DSI 9363-011
Job Sheet 198731

DESIGN CB	DRAWN BY CB	DART AEROSPACE LTD HAWKESBURY, ONTARIO, CANADA	
CHECKED LE	APPROVED #	DRAWING NO. DSI 9363	REV. A SHEET 1 OF 1
DATE 07.01.19		TITLE SHIM KIT	SCALE NTS
A	07.01.19	NEW ISSUE

DART SERVICE INSTRUCTION

TO AMEND INSTALLATION INSTRUCTIONS IIN-D412-694 REV. B AND INSTRUCTIONS FOR CONTINUED
AIRWORTHINESS ICA-D412-694 REV. 1
REF. CANADIAN STC: SH05-10
REF. FAA STC: SR02086NY

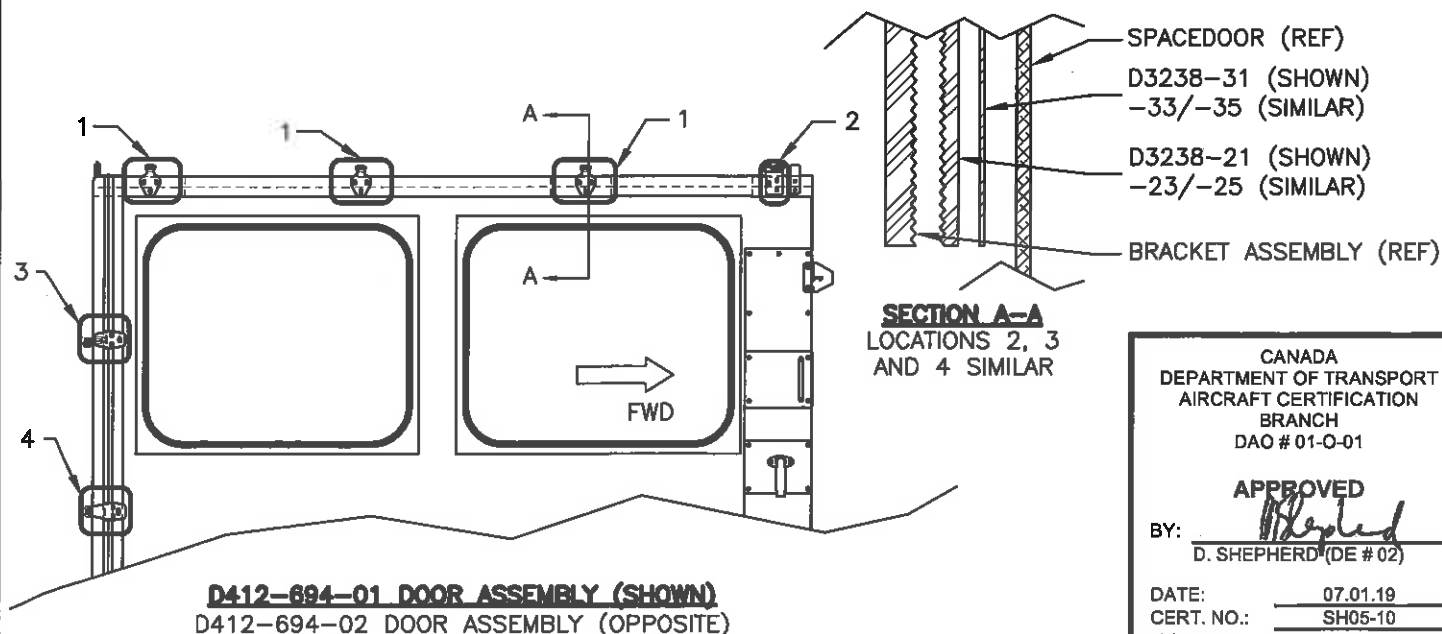
Dart has created the optional DSI-9363-011 Shim Kit that may be installed between the D3121-041/-043/-044, D3183-041/-042 and D3137-041 Bracket Assemblies and the Spacedoor™ to improve grip between the Bracket Assemblies and the Spacedoor™. This kit may be installed as a replacement for or in addition to the AN960JD10 Washers and/or the D3090-1/-3 Shims used to shim the Bracket Assemblies as described in the Installation Instructions.

The serrated faces of the D3238-21/-23/-25 Plates should be installed against the serrated faces of the Bracket Assemblies to ensure positive locking as shown in **Section A-A**. The D3238-31/-33/-35 Plates, the AN960JD10 Washers and the D3090-1/-3 Shims can be installed as required between the D3238-21/-23/-25 Plates and the Spacedoor™ to achieve good door alignment.

The Table and Figure below show the location, the quantity and the part number of each Plate and the corresponding Bracket Assemblies on the Spacedoor™.
